# FMB125 Product Change Notifications

**Product change notifications (PCN)** is the way of informing customers of upcoming changes related to Teltonika products. This includes outward appearance adjustments, hardware improvements, firmware changes, changes to package contents, etc. This page stores information regarding changes to the FMB125 tracking device. Below you will find a list of both upcoming and already implemented changes sorted from newest to oldest (top to bottom).

## 2021.01.01: Top Laser Printing Changes

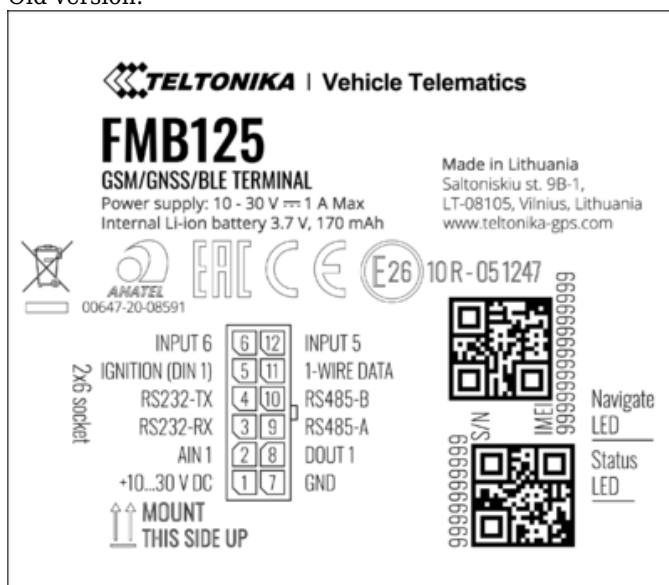
We would like to inform you, that laser printing of the FMB125 device was updated in the factory in January 2021.

Change type	External/visual
	Top laser printing design changed
	Old version:

Change reasons	1. Updated Emark certificate number. 2. Added UKCA label. 3. Updated Teltonika brand to Teltonika Telematics.
----------------	---
